SUBJECT: **EPA07 and EPA10 DD Platform Engines With Low Oil Pressure Codes**

**ISSUE**

**Figure 1 – O-ring Location**

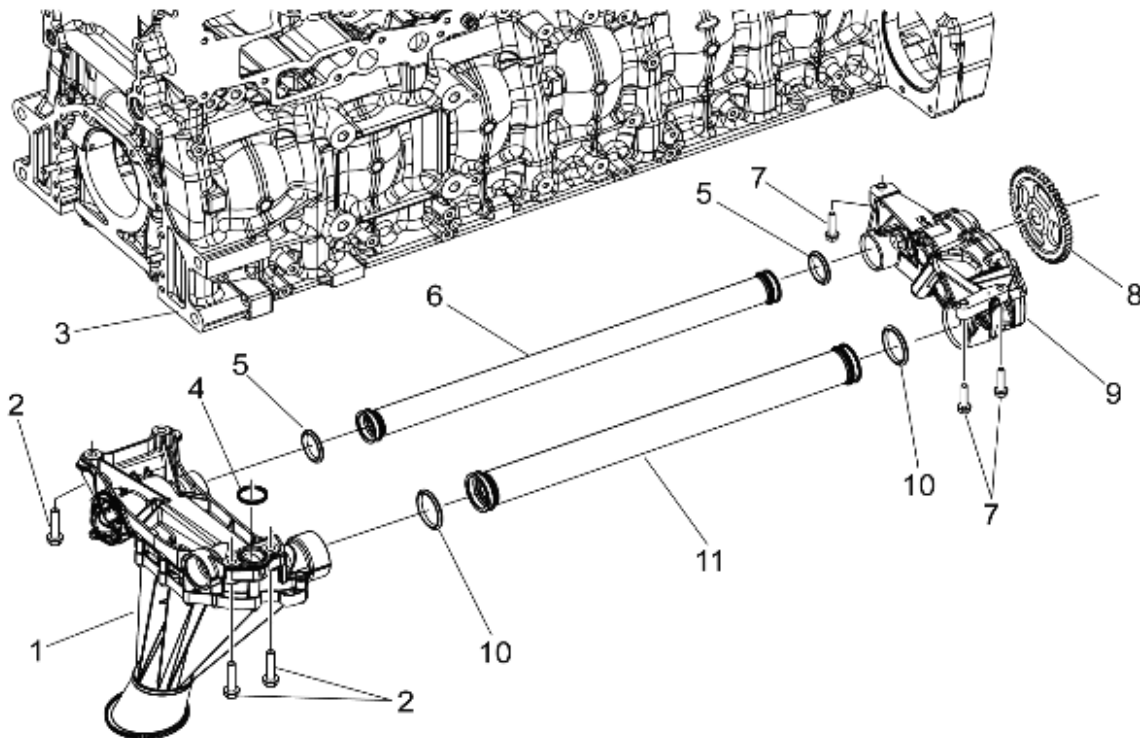
There are five O-rings related to the oil pick-up tube assembly that may become brittle and allow air to enter the engine oil system. This failure mode is experienced only at high mileages – generally, 400,000 miles and greater. See Figure 1. The O-rings in question are item numbers 4, 5 (two locations), and 10 (two locations).

Improved pickup tube seals (item numbers 5 and 10) became effective with engine s/n (last six digits) 170300 built on November 20, 2012. Not all units before the changepoint will have this issue.

Improved oil suction manifold seal (item number 4) became effective with engine s/n (last six digits) 206879 built on August 8, 2013. Not all units before the changepoint will have this issue.

Once low oil pressure codes are verified, the O-rings may need to be replaced. In extreme cases, the rod bearings may need to be inspected and replaced.

Verify low oil pressure complaint with a manual gauge or using DiagnosticLink™. If verified, check the O-rings for item numbers 4, 5 (two locations), and 10 (two locations). Remove the oil pan and inspect for signs of bearing debris. If no debris is found, reinstall the oil pan. If bearing debris is found, remove and inspect the rod bearings. If rod bearings show severe distress, replace the crankshaft. See Figure 2, Rod Bearing Inspection. In extreme cases only, if replacing O-rings for item numbers 4, 5 (two locations), and 10 (two locations), do not give the desired pressure of greater than 11 psi (DD13, DD15TC, DD16) or 10 psi (DD15AT) at idle and operating temperature, the oil suction manifold should be replaced.

**Figure 2 – Rod Bearing**

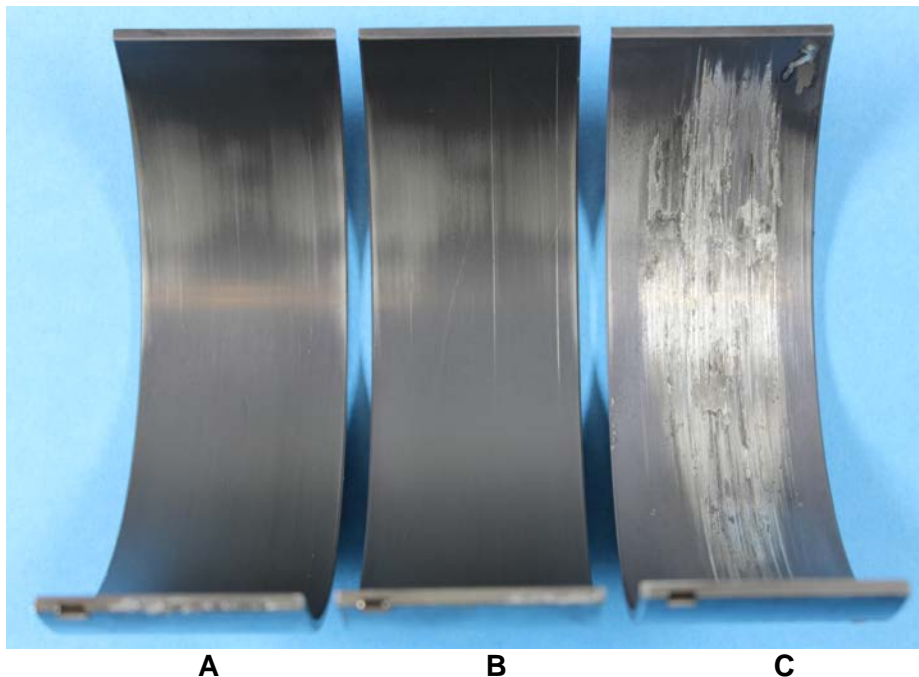
Bearing A – No signs of distress, normal wear for high mileage bearing.

Bearing B – Small scratches on rod bearing surface, but typical for high mileage bearing.

Bearing C – Bearing surface shows heavy signs of damage. Replace crankshaft, main bearings, and rod bearings.

**A rod bearing inspection is only required if signs of metal debris are present in the oil pan.**
